Technical Memorandum

Title	Flagstone Coles RFI Response		
Client	Coles Group Property Development	Project No	CEB06761
Date	20 July 2018	Status	Final
Author	Alex De La Flor	Discipline	Traffic and Transport
Reviewer	Daniel Suman	Office	Brisbane

A submission has been lodged to make minor amendments to the current Development Approval of the Coles Flagstone approval package issued by Economic Development of Queensland (EDQ) on 6 October 2016 (EDQ Reference DEV2016/776). Cardno has prepared responses to the information request provided by EDQ in relation to the traffic components on 4 July via email correspondence included at Appendix C.

Figure 1 Roundabout Concept Signage Plan

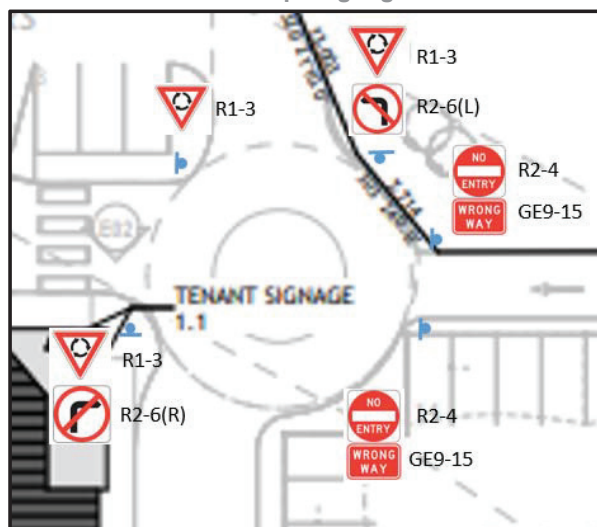
- a) The location of the eastern leg of the roundabout proposed as an approach to the roundabout can be confused by drivers using this as a departure leg. Consider review of the geometry in concept and detailed design;

A one-way approach at the eastern leg of the roundabout is considered an acceptable arrangement. Suitable signage from the other approaches indicating one-way direction or no through access at the eastern approach should be installed. As shown in Figure 1, a concept plan has been provided to illustrate the signage arrangement. Figure 1 has been prepared generally in accordance with the Manual of Uniform Traffic Control Devices (MUTCD) standards and requirements.

Coles Group Property Developments Ltd
Coles Flagstone
6.4m Small Rigid Vehicle
Swept Path

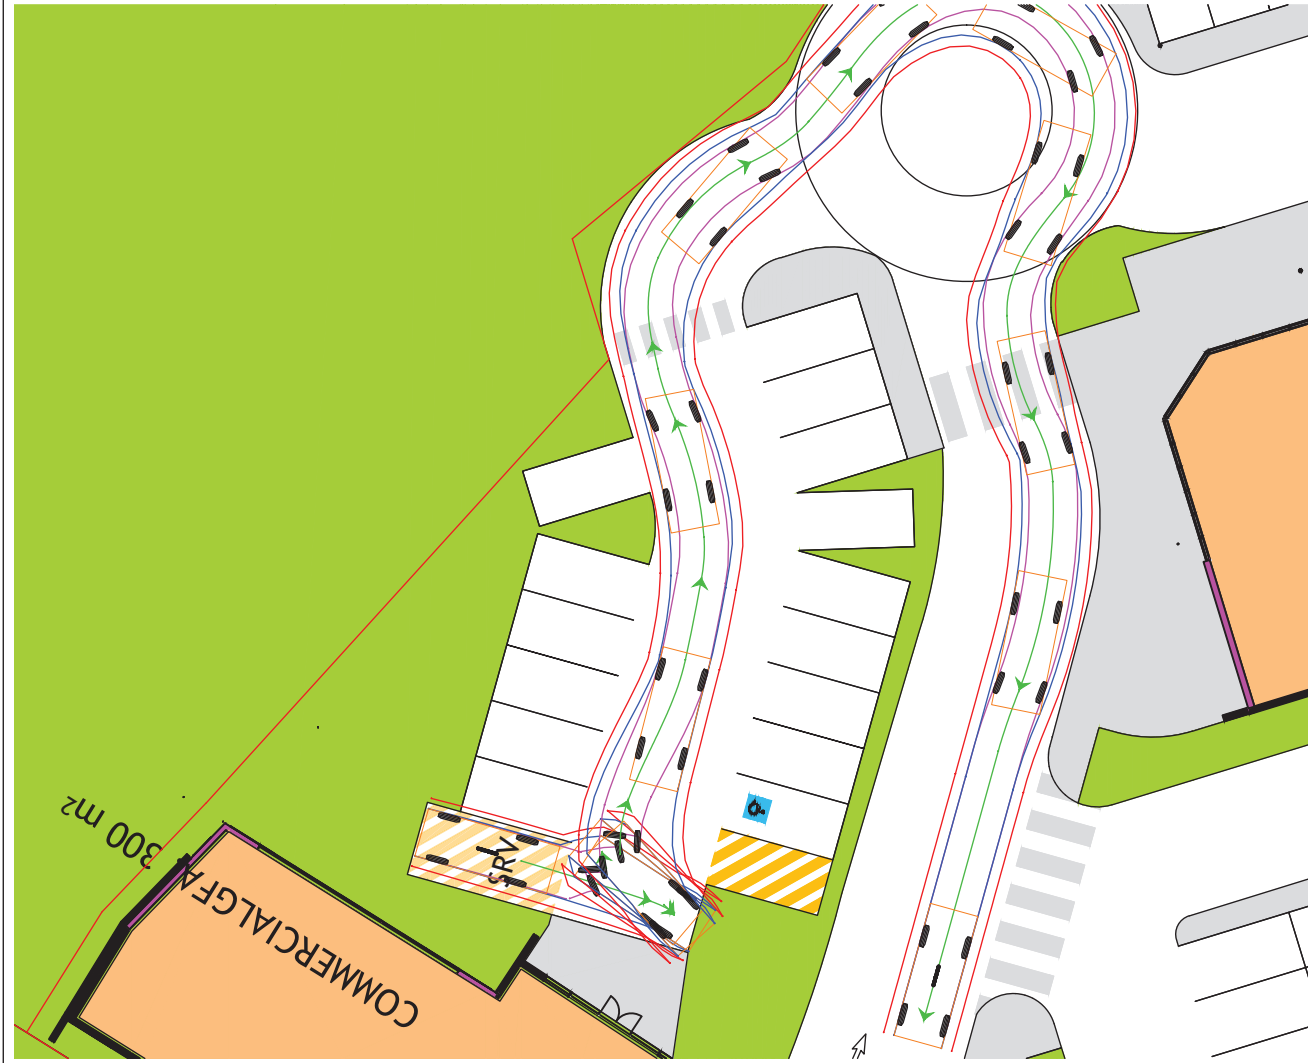
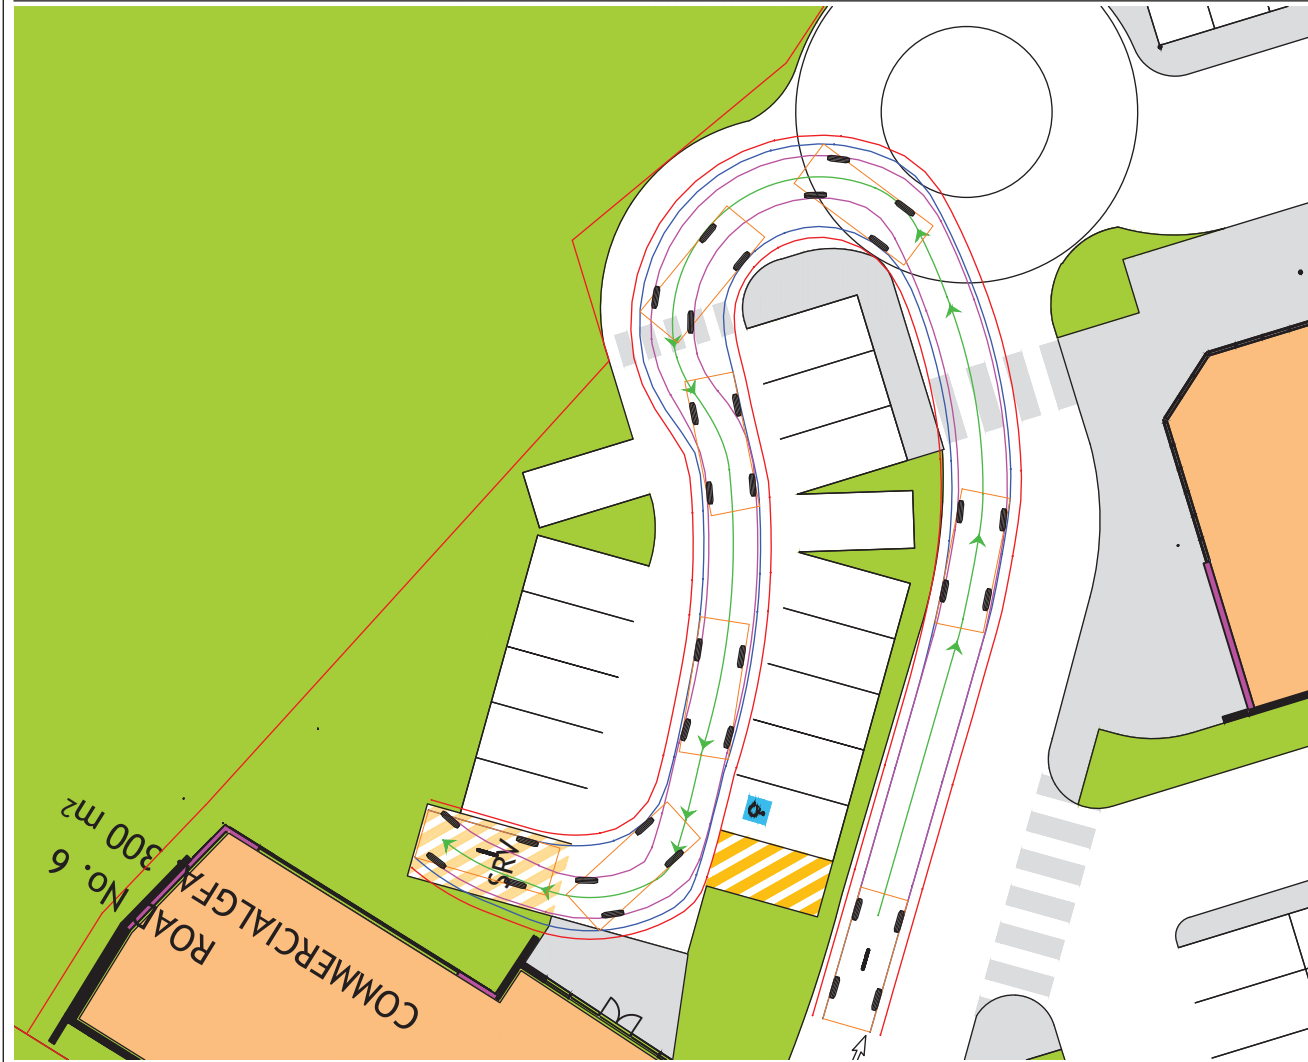
- a) Demonstrate a refuse collection vehicles (RCV) and SRV can manoeuvre within the commercial building car park.

A swept path assessment demonstrating an SRV manoeuvring within the commercial building component has been included at Appendix B. The height of surrounding features including the commercial entrance will be designed to accommodate the SR swept path shown at Appendix B, at the detailed design stage. The SRV loading dock dimensions accord to AS2890.2. The servicing arrangements for the commercial tenant will utilise the small retail loading dock at the northern end of the supermarket.

The refuse collection is recommended to be undertaken outside operating hours given the size of an RCV and its limited manoeuvrability.
